**CITY OF SAN JUAN**  
**LIFT STATION No. 6 RELOCATION PROJECT**  
**RFB NO. 25-005-04-09**  
**ADDENDUM NO. 5**

**Addendum Date: April 15, 2025**

PROJ. NO.: 23.016  
DESIGNED: RS  
DRAWN: CF/JP  
DRAWING NUMBER C10  
SHEET NUMBER 13 OF 72

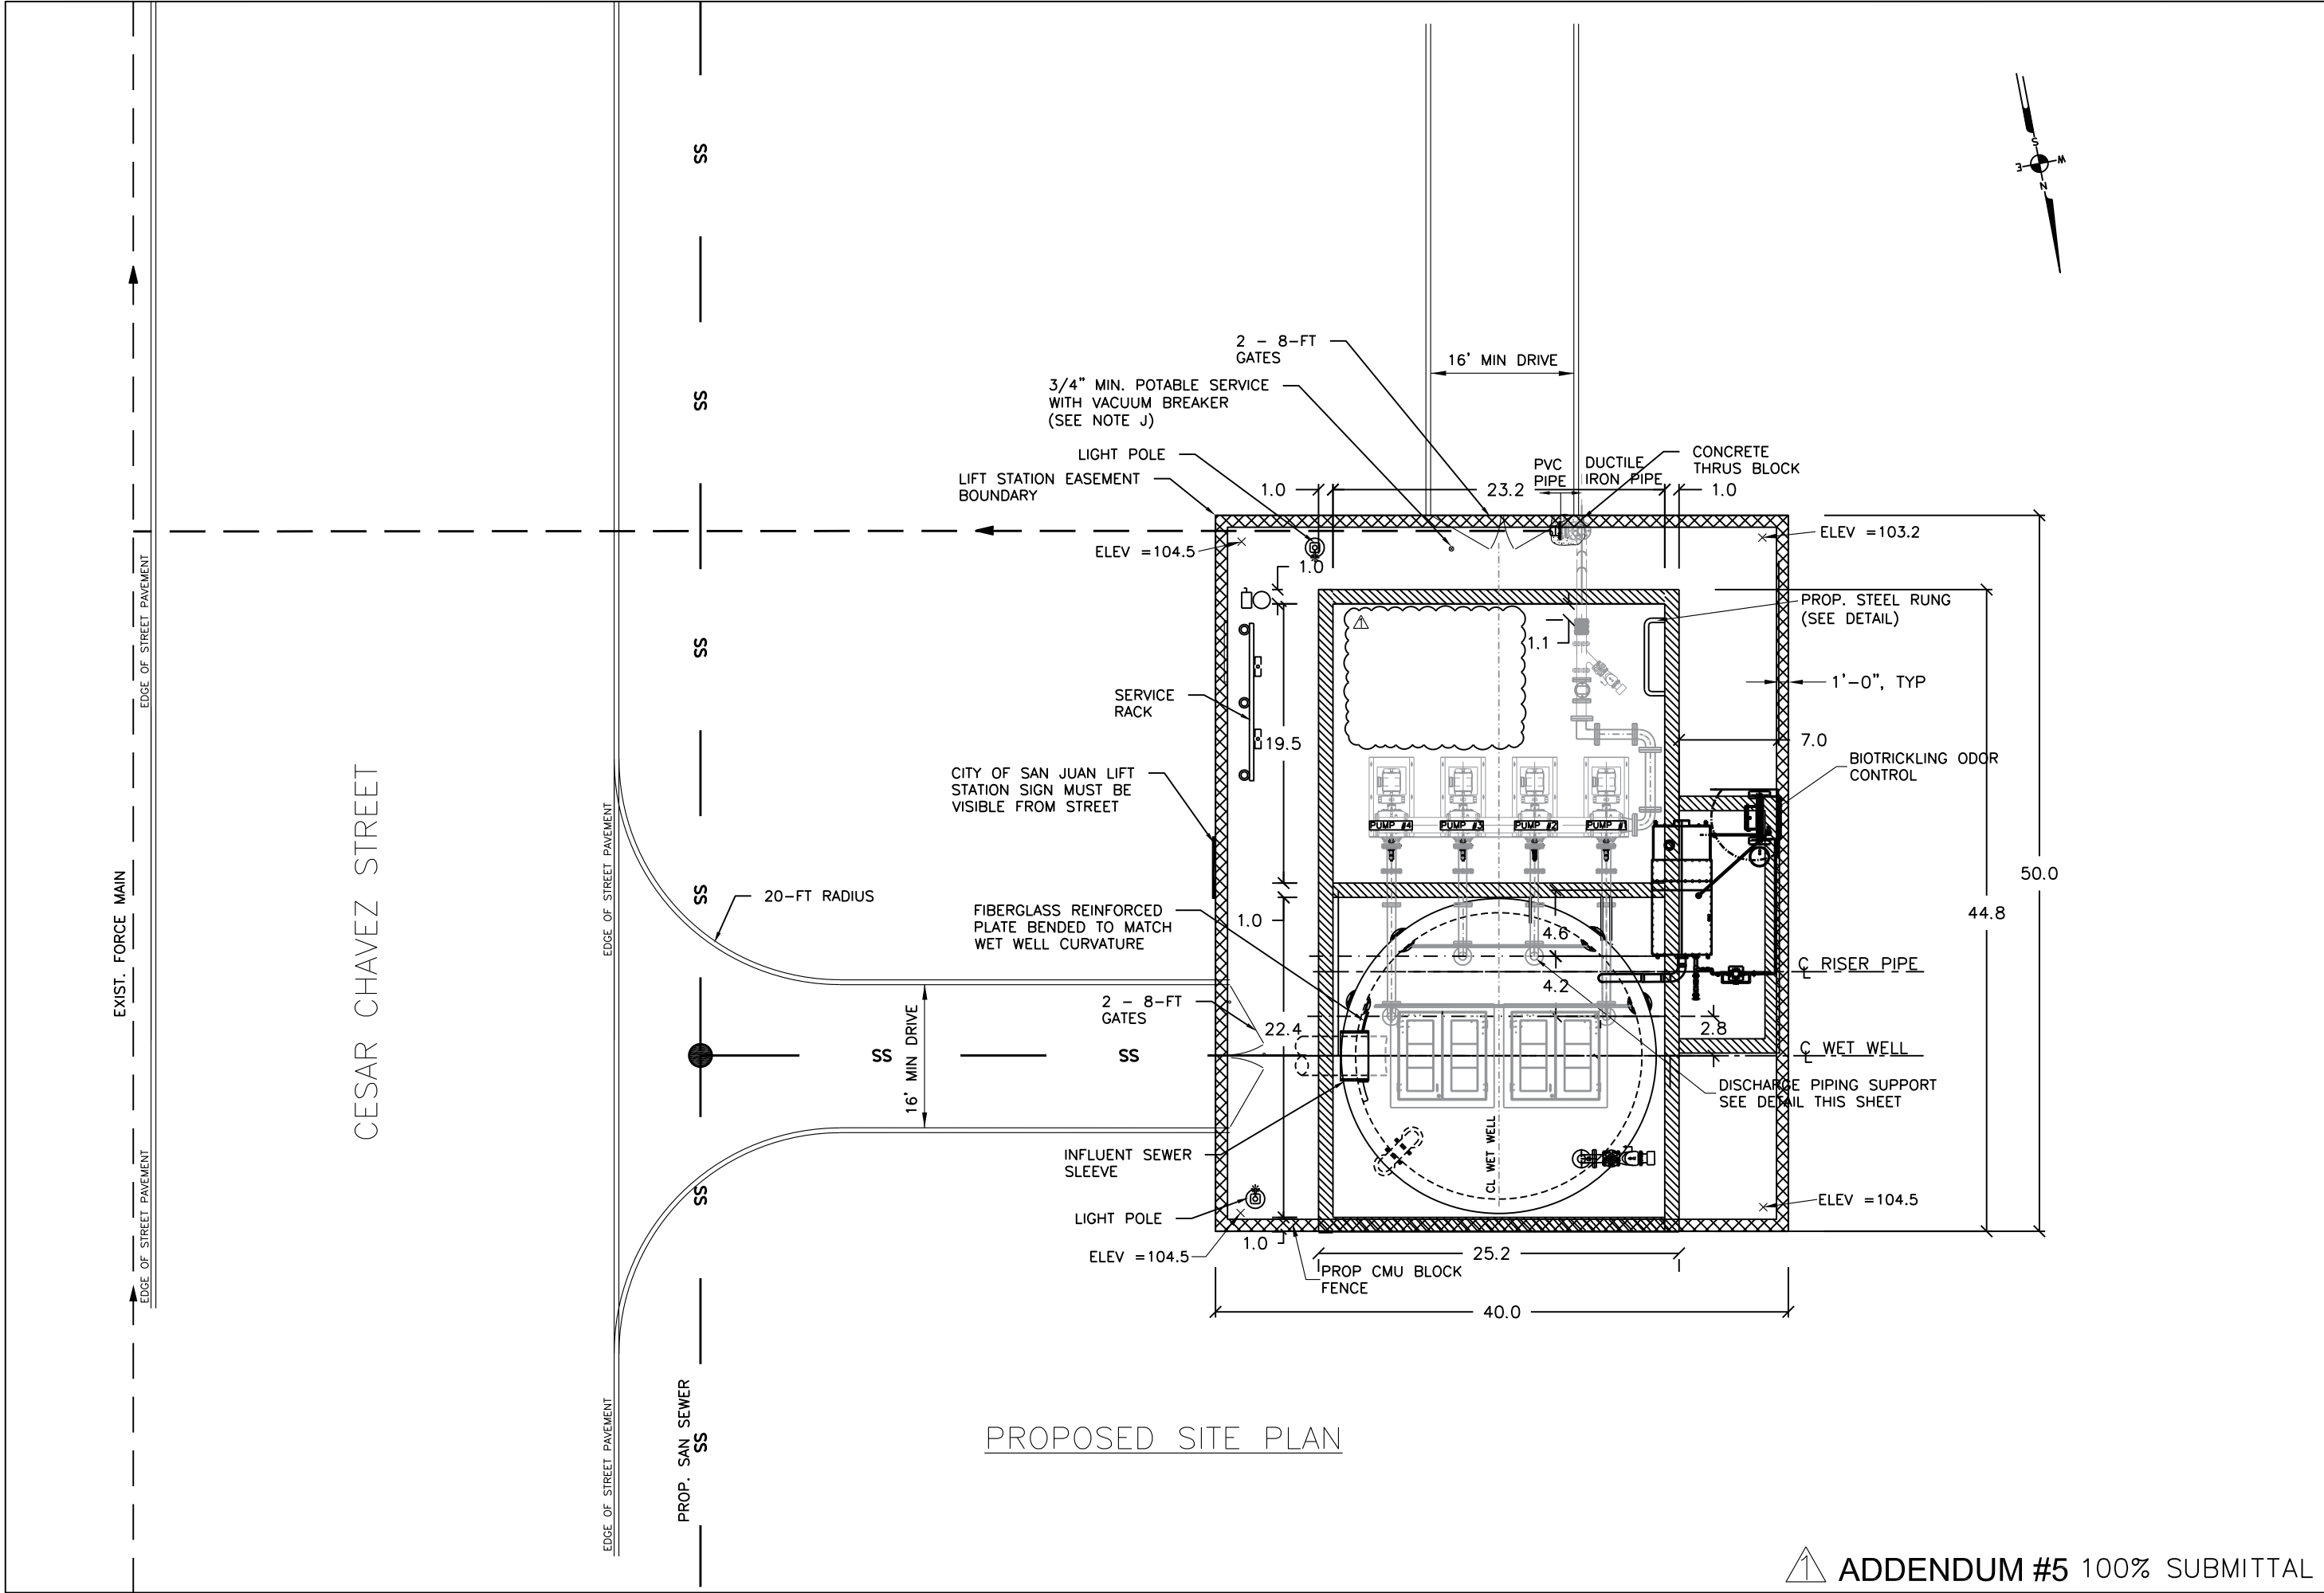
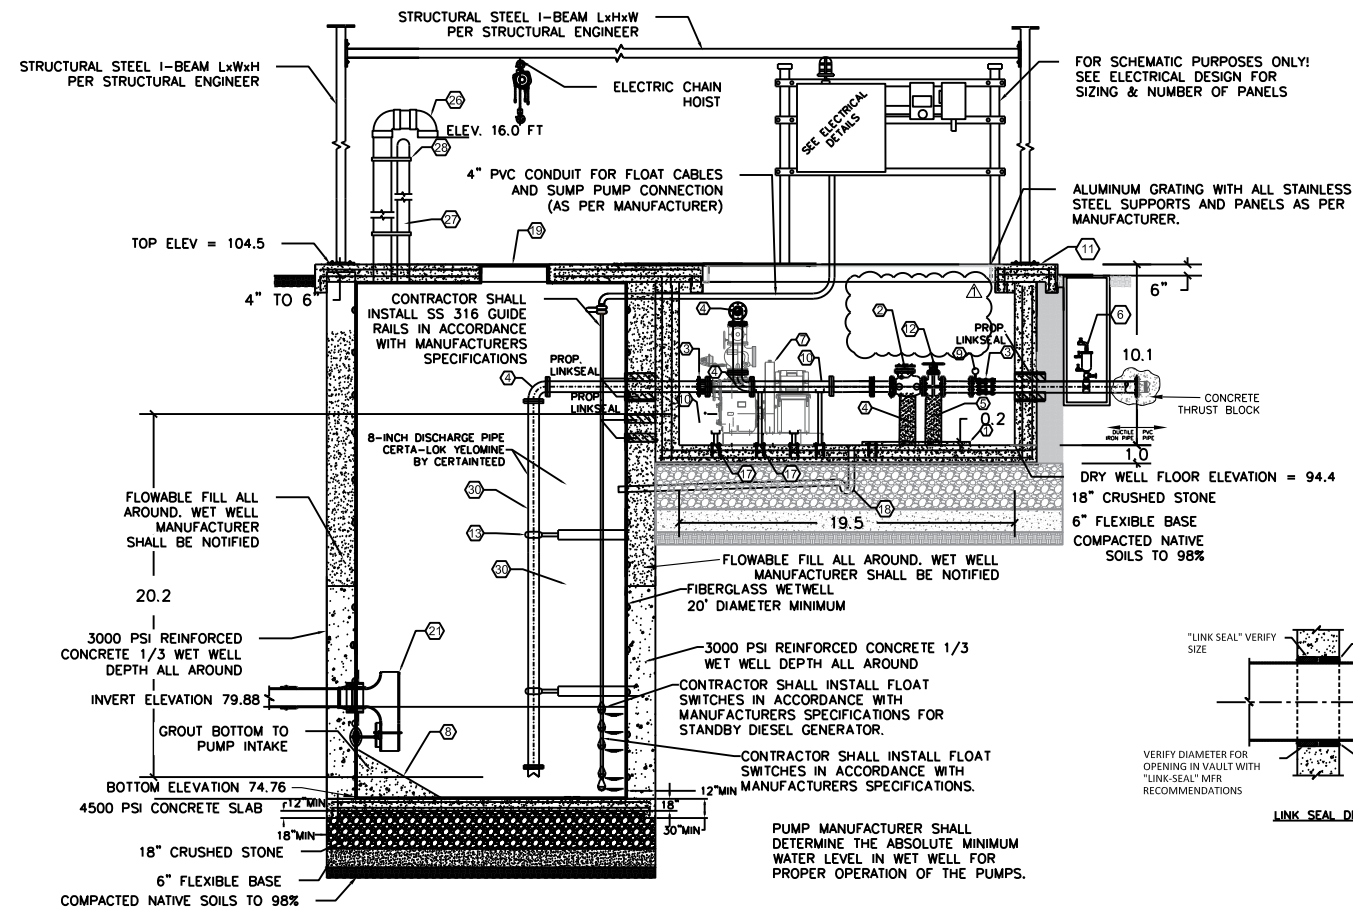
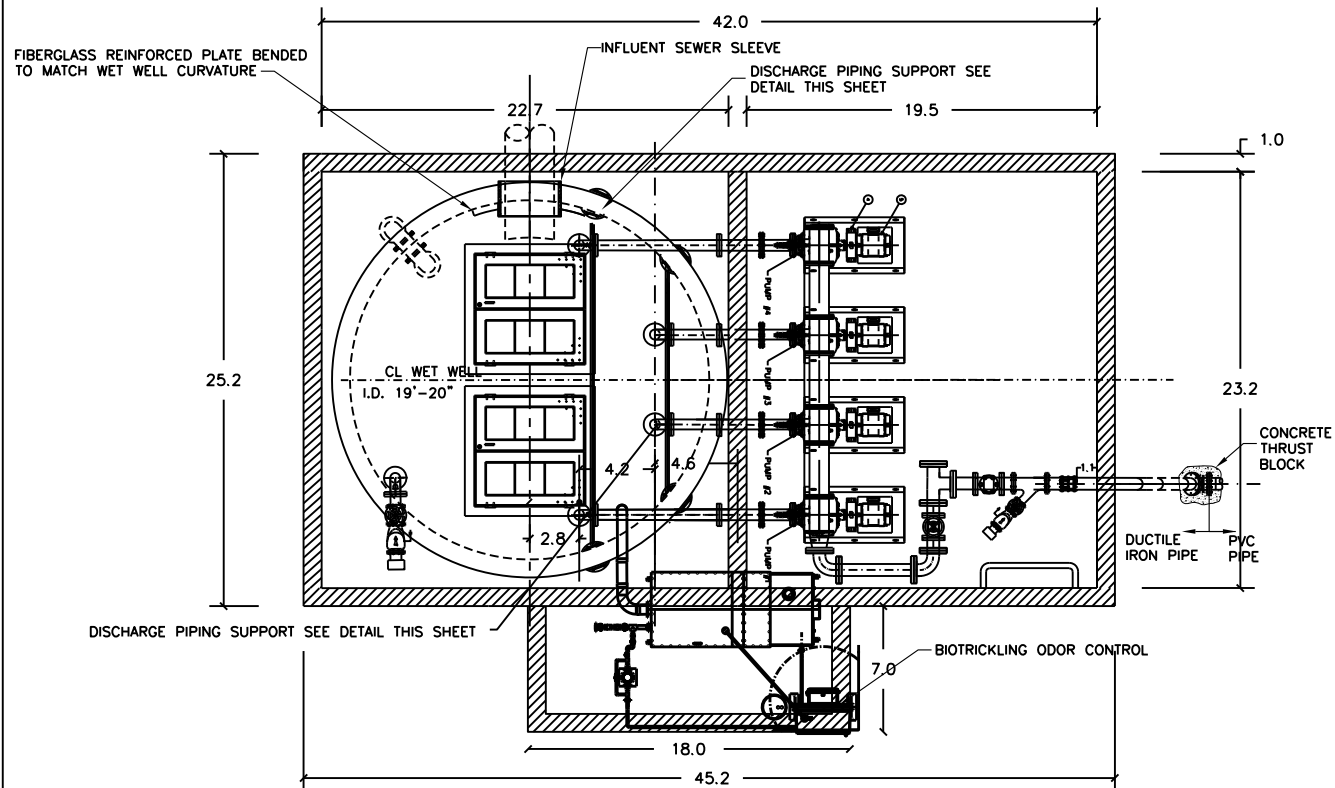
- It will be 2-tons.
24. Sheet C8 shows hay bail, but details for this item is missing in drawings, please clarify.
- Will add hay bail detail to sheet C10. See attached.

25. Sheet C10 shows details #2, #3 & #4, but these are missing in plans, we didn't provide takeoff for these items, please clarify.
- Details in SW3P detail sheet are generalized. If detail not needed do not consider part of your bid.

PROJ. NO.:	23.016
DESIGNED:	RS
DRAWN:	CF/JP
DRAWING NUMBER	L12
SHEET NUMBER	54 OF 7

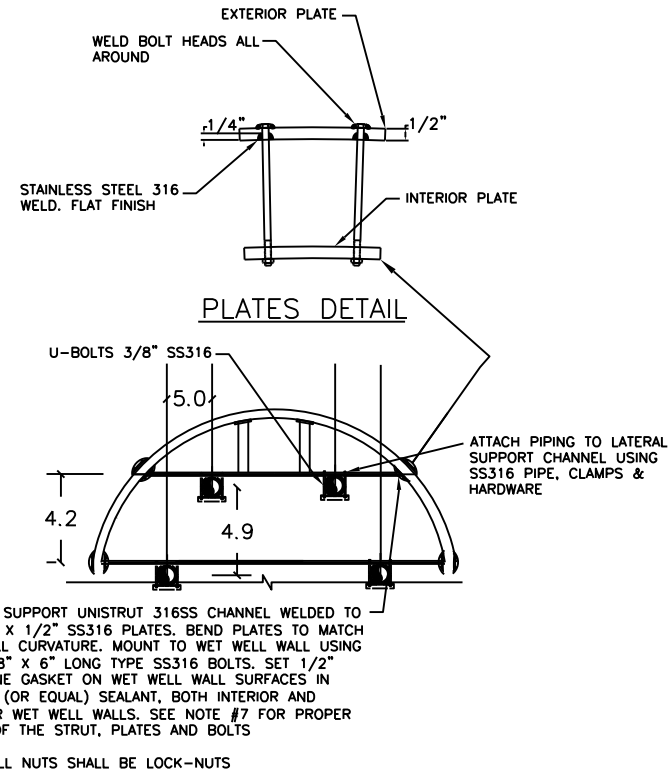
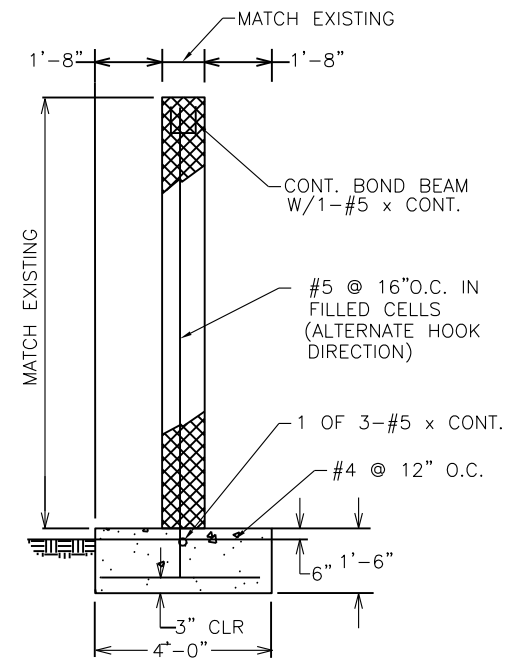
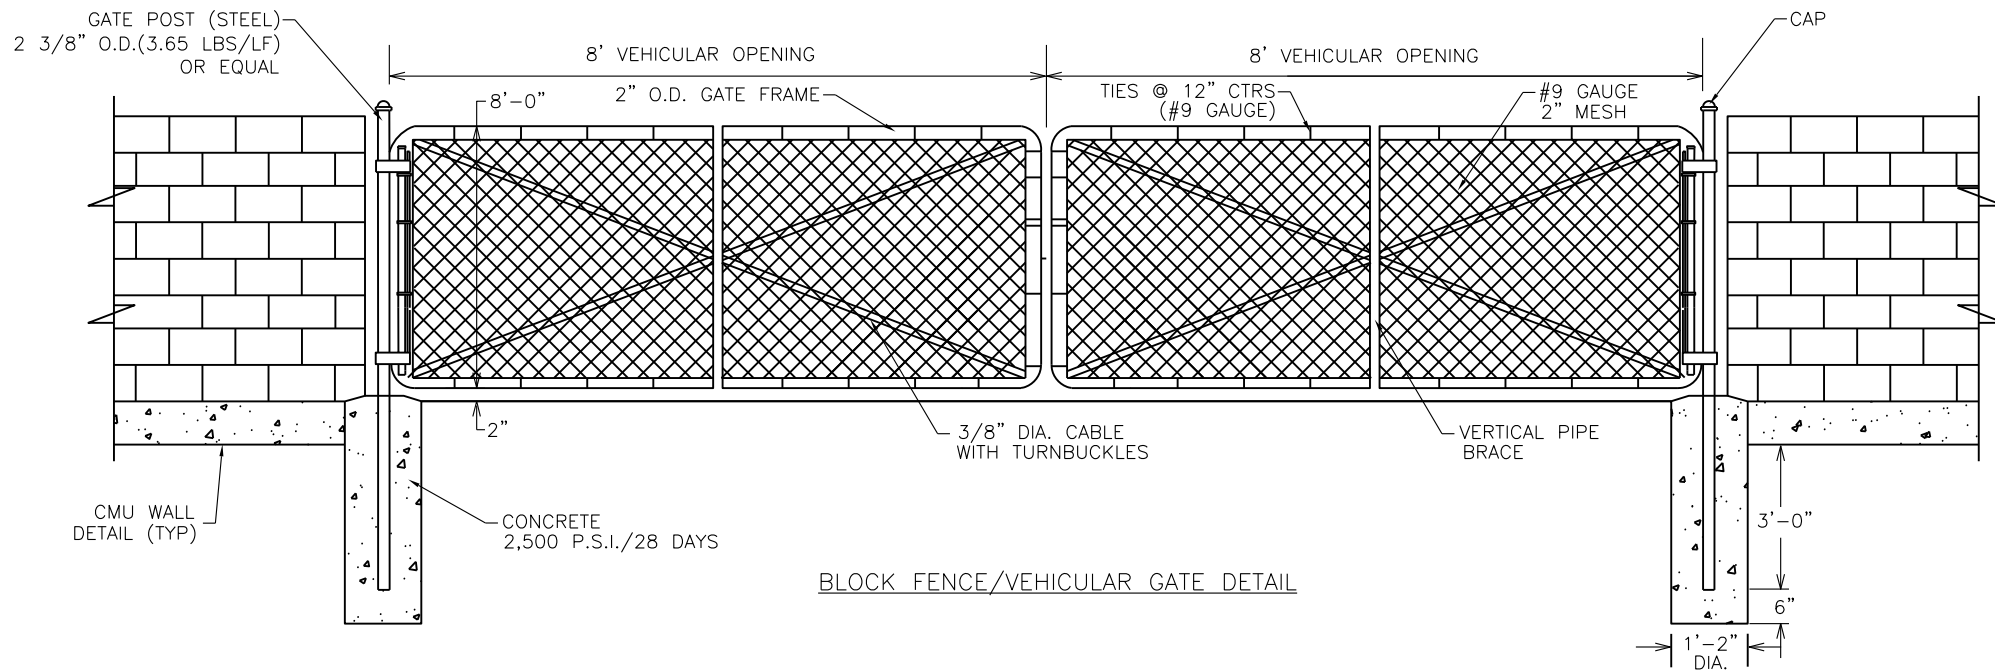
- Please see Section 09800 for paint and coating requirements. This item is to be included in Item No. 18 of Proposal Section 00300.
5. Sheet L04, profile view at grade shows grout bottom to pump intake, but scope of this item is missing in plans, we assumed an area for this item, please clarify.

- Call out No. 8 on Sheet L04 requires the bottom of the wet well to be sloped with cementitious grout as per plans and is included in Item No. 18.
6. Sheet L12, detail storm runoff protection shows inside lift station site pavement, but type and scope of this pavement is missing in plans, we assumed an area for this item, please clarify.

- Detail for Storm Runoff Project Detail is for the use of a hurricane fence only and shall be removed from Sheet L12.
7. Scale for structural drawings sheet is missing we calibrate the scale with one of given dimension in plans, please clarify.
